Newmar Corporation

RSB 597
April 28, 2023

RECALL SERVICE BULLETIN

GLOBAL ENTRY DOOR LATCH INSPECTION/ REPLACEMENT INSTRUCTIONS *MOTORIZED UNITS ONLY

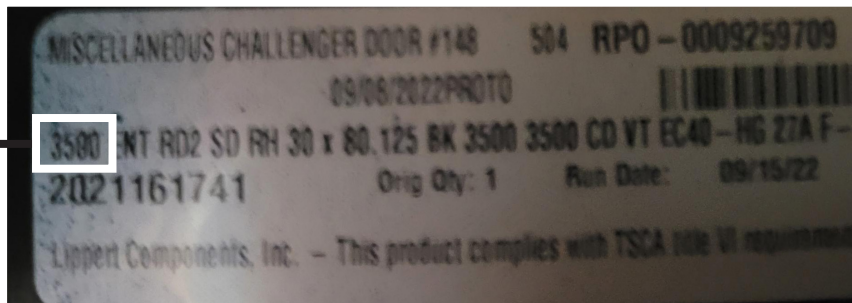
The replacement latch assembly part is determined by the serial number on the door tag. Replacement inside latch assembly for the 920 Series door is PN 2023005033. Replacement inside latch assembly for the 3500 Series door is PN 2022010407.

Fig. 5

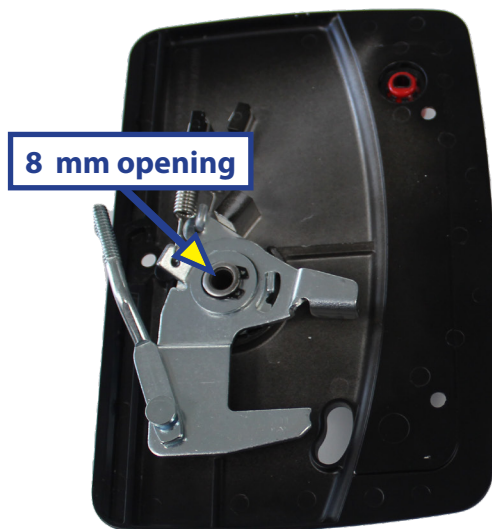
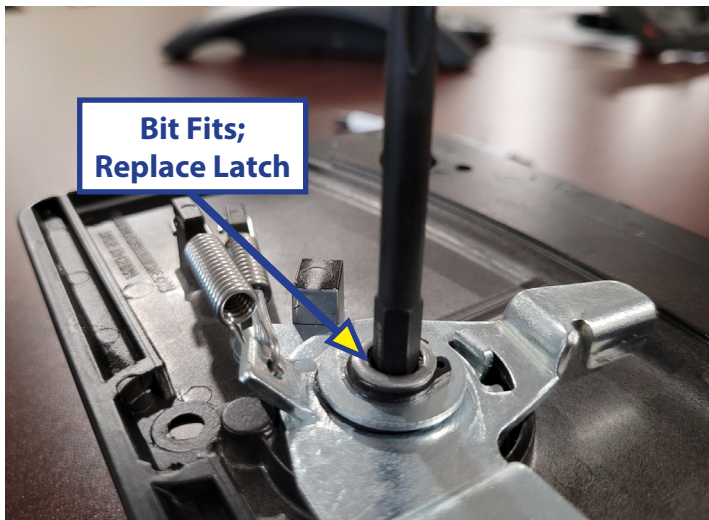
- Using a 1/4" screwgun bit, try to insert the bit into the spun rivet of the inside latch assembly (Fig. 5).
- If bit fits into rivet opening there are two options:
 - Replace the complete latch assembly, including both inside and outside latch assemblies.
 - Replace just the inside latch assembly to be combined with current outside latch assembly.
- If the bit does not fit, no action is required. Proceed to latch reassembly instructions.

New Inside Latch Assembly Needed

Replacement Not Needed
